## Application for Licence

<b>Licence Number</b>	L9289/2021/1
<b>Applicant</b>	GWR Group Limited
<b>ACN</b>	102 622 051
<b>File Number</b>	DER2021/00143
<b>Premises</b>	Wiluna West Project Sandstone-Wiluna Road, WILUNA  Legal description Partially within M53/1087 As defined by the coordinates in Schedule 1 of the Licence
<b>Date of Report</b>	12 August 2021
<b>Decision</b>	Licence granted

This Decision Report documents the assessment of potential risks to the environment and public health from emissions and discharges during the operation of the Wiluna West Project (the premises). As a result of this assessment, Licence L9289/2021/1 has been granted.

**Figure 2: Site layout of crushing / screening plant**

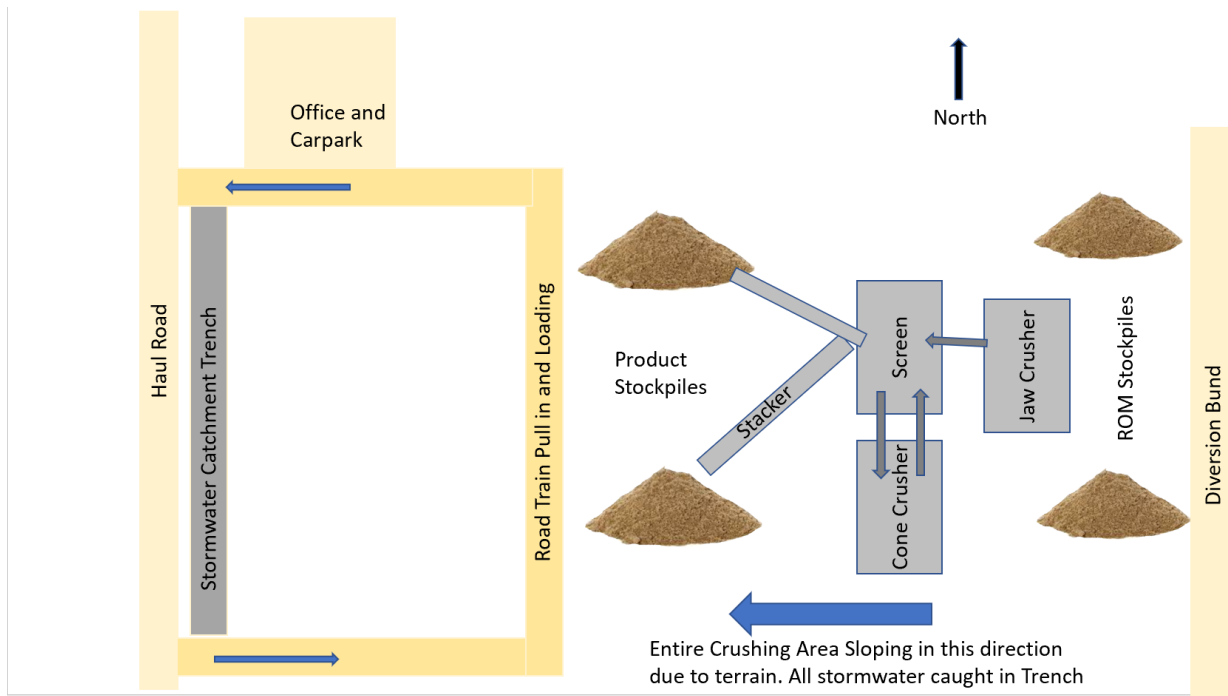
Rather than a trench around the perimeter of the Run of Mine pad (ROM), the design of the stormwater catchment trench has been amended to be one trench at the western end to which the crusher/stockpile area slopes down towards, see Figure 2. This trench has the same capacity as that which is outlined in Table 1 of Works Approval W6444/2020/1. Refer to section 2.2.3.

During construction, the applicant took advantage of the natural slope of the premises to amend the design of the stormwater catchment structure to be a single trench at the western end of the crusher/stockpile area. This is intended to prevent potentially contaminated stormwater from the plant and ROM area flowing into the surrounding environment.

After a rain event the stormwater will be pumped out and transported to the HDPE lined turkey's nest. The applicant will ensure a pump with sufficient pumping capacity is maintained to ensure the trench does not overflow.

The Delegated Officer's review of the changes to the stormwater management system has confirmed that the adjustment to the catchment trench design is minor in nature. The altered trench design is expected to achieve the same outcome as the original design which is to capture surface runoff of sediment laden stormwater and washdown water. The change does not alter this risk profile of the premises. The Delegated Officer is satisfied that works have been completed adequately, in accordance with the conditions of the works approval.
